ANNEXURE 2

LANE COVE DCP ASSESSMENT PART C8 TABLE OF COMPLIANCE

TABLE OF COMPLIANCE – LANE COVE DEVELOPMENT CONTROL PLAN 2010 PART C – RESIDENTIAL LOCALITIES – LOCALITY 8 – ST LEONARDS SOUTH PRECINCT				
Section	Control	Requirement	Proposal	Complies

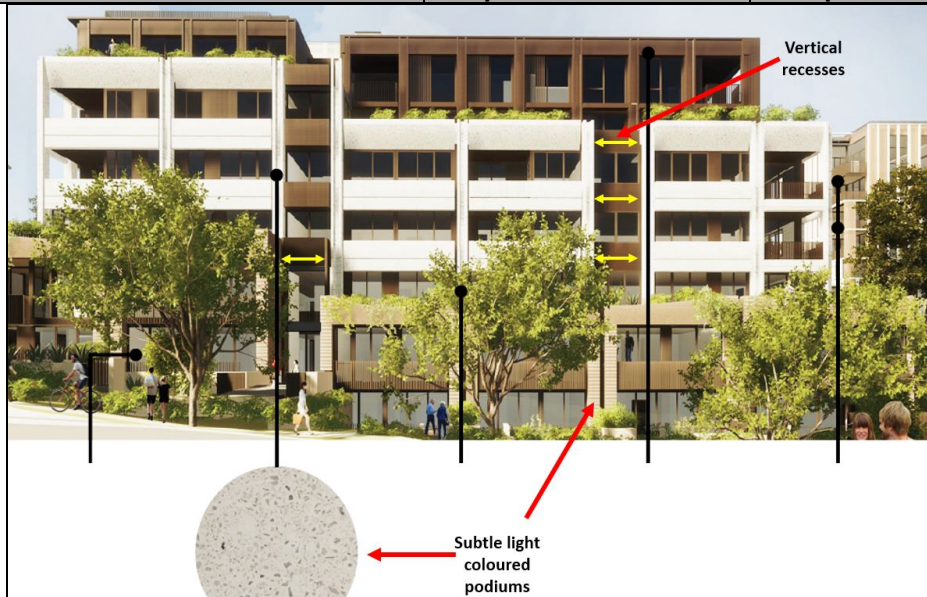
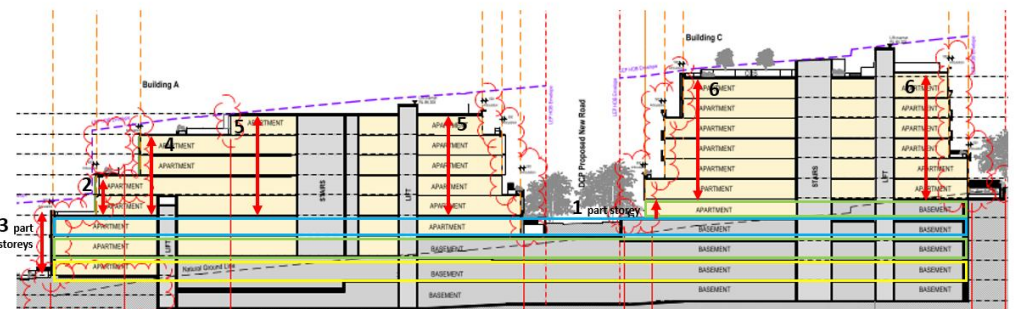
Section	Control	Requirement	Proposal	Complies
		<div></div> <p>Area 22 (Park Road frontage) montage with compliant articulation provided</p>		
Height in Storeys				
Height of development in number of storeys as per Figure 10. Refer also to Clause 4.6(8)(cb) and Part 7 of LEP.		Height in storey control complied with. Building A: 3 - 6 storeys Building B: 3 - 10 storeys Building C: 6 storeys Building D: 10 storeys	Yes	
Part storeys resulting from excavation of steep slopes or semi-basement parking will not count as a storey.		3 part-storeys at River Road (Buildings a & B). 1 part-storey at New DCP Road (Building C) 2 part-storeys at New DCP Road (Building D)	Yes	
<div><div>PART STOREYS   </div><div></div></div> <p>Section of Park Avenue Buildings (A and C) - compliance with height in storeys controls.</p>				
Solar Access				
Compliance with ADG.		The proposal provides for the following:	Yes
